Federal Motor Vehicle Safety Standards; Designated Seating Positions

ACTION: Final rule; response to petitions for reconsideration.

SUMMARY: This document completes the agency’s response to petitions for reconsideration of an October 2008 final rule that amended the definition of the term, “designated seating position,” as used in the Federal motor vehicle safety standards, to facilitate the determination of which areas within the interior of a vehicle meet that definition. The final rule made the new definition applicable to vehicles manufactured on and after September 1, 2010. Previously, the agency granted petitions requesting one year of additional lead time until the new definition became applicable, removal the portion of the regulatory text stating that State tort law requirements are preempted, and technical corrections. This final rule addresses the remaining issues raised in the petitions for reconsideration and

Figure 1: Global Automakers Seat Surface Width Measurement Example

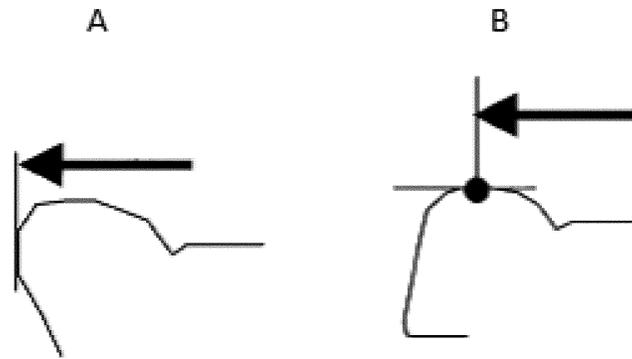
Global Automakers and Toyota requested that the agency clarify its position on how the seating surface width is measured. Global Automakers raised two specific scenarios. The first scenario involves seat cushions whose outer edge slopes downward. Global Automakers was not certain whether the measurement will be made from the outer edge of the seat cushion (identified in A in Figure 1) or the point where the top surface of the cushion begins sloping downward toward the side of the seat (identified as B in Figure 1). Toyota interprets the language as contemplating the seating surface width measurement to take place between the vertical planes tangent to the outboard edges of the seat, as indicated in Figure 2. Toyota stated that if its interpretation is not correct, it was petitioning the agency to adopt its position.

NHTSA agrees with Toyota's interpretation that the seating surface width will be determined from the maximum width between the vertical planes tangent to the outboard edges of the seat. We note that in the context of seat width measurement, the determination of what is outboard is made with respect to the seat orientation and may not align with what is outboard with respect to the vehicle. This measurement procedure is more

objective than the other measurement procedure suggested by Global Automakers. It is not always clear at what point the top surface of the seat cushions begin to slope downward to the side because such surfaces may be rounded or uneven and seat cushions can be pliable.

NHTSA would measure the seating surface width from the plane indicated in drawing A on Figures 1 and 3 above. NHTSA would only consider a trim component in the determination of the seating surface width if the trim makes contact with the top of the seat within the measurement zone. To make this clearer, we are adding specificity to the determination of the "seating surface width."

Figure 3: Global Automakers Seat Surface Width Measurement with Armrest

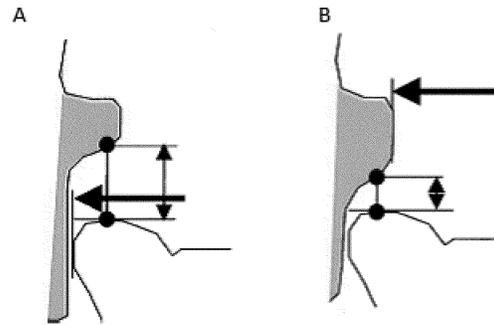
Global Automakers also requested that the agency clarify its interpretation

on how the measurement will be taken for seat cushions whose outer edge extends underneath interior trim. Global Automakers noted that, in some cases (one of which is illustrated in Figure 3 below), the interior trim interrupts the "nominal hip room" using the SAE H-point machine and that an occupant could not use the seating surface under the trim.

Shaded area is body-side armrest. 'B' cannot accommodate 3-D manikin in void between armrest and seating surface.

Although the agency agrees that, in Global Automakers' example, some portion of the "seating surface" may not be a location where an occupant could actually sit, the amendment to the DSP definition was designed to make the definition more objective. The new definition is not based upon non-objective concepts such as the usability of the seating surface by the occupant or "nominal hip room." Manufacturers will have to consider the usability of the space in designing the vehicle; however, the DSP definition and measuring procedure make no allowance for seating space that is made unusable by the positioning of trim components such as body-side armrests.

If the seating surface is interrupted by outboard interior trim in contact with the top edge of the seat, the vertical plane used in determining the seating surface width will be the plane that intersects the most inboard point of contact between the interior trim and the point of contact with the top of the seat. We have also added a figure to the regulatory text to illustrate the measurement procedure, including how trim components making contact with the seating surface affect the measurement.

Figure 4: SAE Examples of Seat Measurement with Trim
(Seats in both examples are viewed from above)

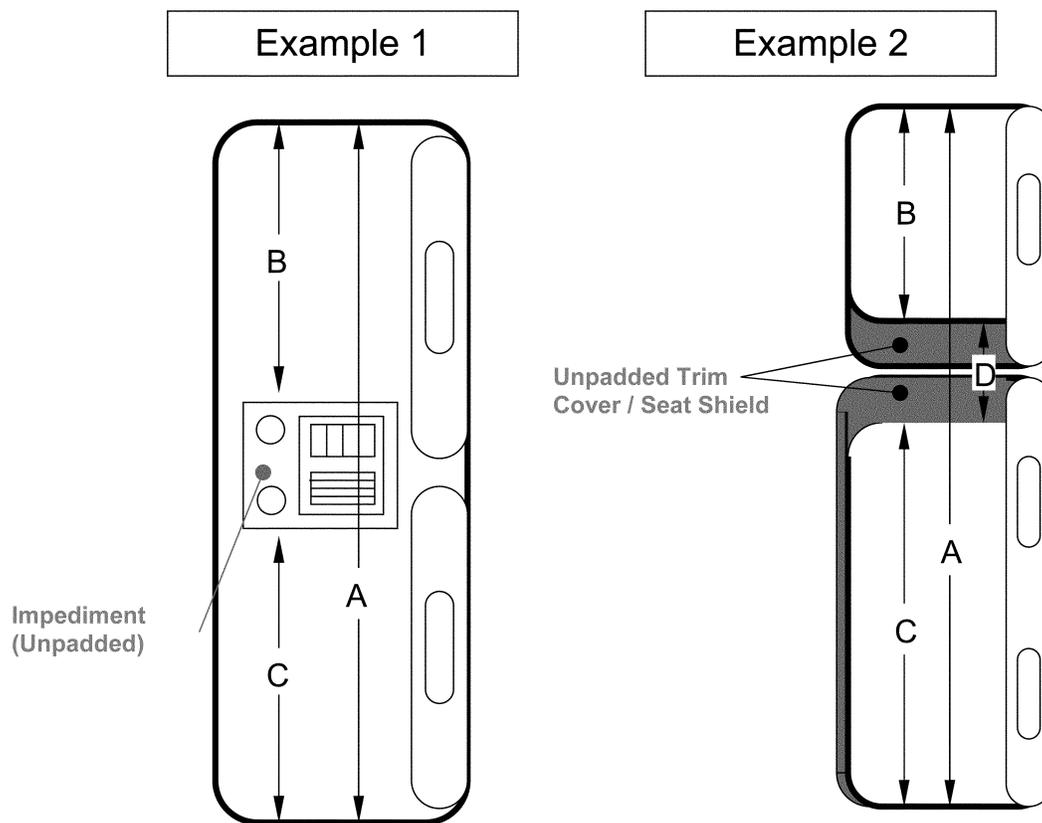
SAE requested clarification on how the agency would consider trim when measuring the seating surface. SAE provided two illustrated examples, shown below, and asked for NHTSA's clarification on how "trim" would be defined.

In Example 1, SAE described an impediment in the middle of the seat as an “embedded convenience system.” During the seating surface measurement, the agency would first determine if the impediment meets the requirements of sections 571.10(c)(2)(i)(A) or 571.10(c)(2)(ii). SAE stated in its request that it was assumed that the conditions of section 571.10(c)(2)(ii) were not met by the impediment.⁷ Therefore, a determination would need to be made as to whether the impediment was “a fixed trimmed surface whose top surface is unpadded and that has a width not less than 140 mm (5.5 inches), as measured in each transverse vertical plane within that measurement zone.” Such a determination is impossible to make from the schematic provided and may only be possible from a physical examination of the impediment. If the impediment satisfied the criteria, the seating width would end at the impediment’s edge, as shown by dimension “B” and “C.” However, if the impediment did not satisfy the criteria, the agency would define the maximum seating surface width as shown by

SAE asked about the measurement procedure with respect to Example 2. We believe this has been made clear both in the regulation and the agency’s test procedure. Assuming the shaded area is fixed, unpadded trim surface, the determination of seat surface width depends on whether the length of “D” is less than 140 mm. If “D” is less than 140 mm, then seating surfaces “B” and “C” form a continuous seating surface and the number of DSPs would be calculated using measurement “A.” If “D” is at least 140 mm, seating surfaces “B” and “C” would have sufficient separation such that the number of DSPs for seating surfaces “B” and “C” would be calculated separately based on the length of “B” and “C.”

distance “A” in Example 1. We think this is clear from a reading of section 571.10(c)(2).

FIGURE 1: Example Measurements for Seat Cushion Width

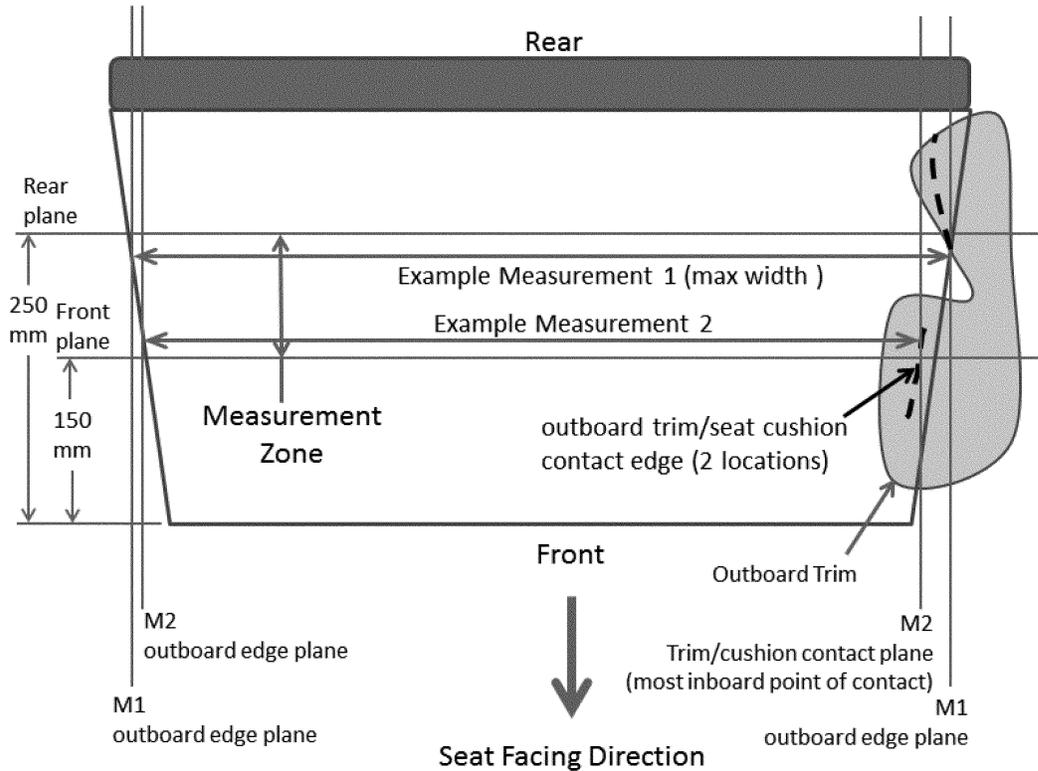
Furthermore, SAE requested the agency's position on how the "front leading surface" would be defined when seats are angled such that the centerline of the seat is not parallel with the centerline of the vehicle. SAE asked the agency for confirmation of its interpretation that an "X" plane tangent to the frontmost edge of the seat cushion is used to measure the 150 mm and 250 mm distance from the front leading edge.

With respect to angled seats, the agency did not intend the "front leading surface" to be defined in the manner described by SAE. Rather, the agency intended the measurement zone to be determined from the front leading surface of the seat in its "forward" facing direction as defined in S4.3 of FMVSS No. 210, regardless of how the seat may be oriented in the vehicle. That is, "forward" refers to the direction in which the seat faces, rather than the direction the vehicle faces, and the measurement zone would be oriented perpendicular to that direction.

(i) Establish a measurement zone bounded by two vertical planes oriented perpendicular to the direction the seat is facing. One is located 150 mm (5.9 inches) behind the front leading surface of the seat and the other is located 250 mm (9.8 inches) behind the front leading surface of the seat. A measurement location within this zone is any vertical plane parallel to the planes establishing the boundary of the zone.

(ii) For each measurement location within the zone, establish vertical reference planes parallel to the direction the seat faces that intersect the most outboard point on each side of the seating surface at that measurement location. If outboard interior trim contacts the top surface of the seat cushion, establish another vertical plane parallel to the direction the seat faces that intersects the most inboard point of contact between outboard interior trim and the top surface of the seat cushion.

(iii) For measurement within the zone, measure horizontally between and perpendicular to the most inboard vertical reference planes established in (ii), as shown in Figure 1 (provided for illustration purposes).
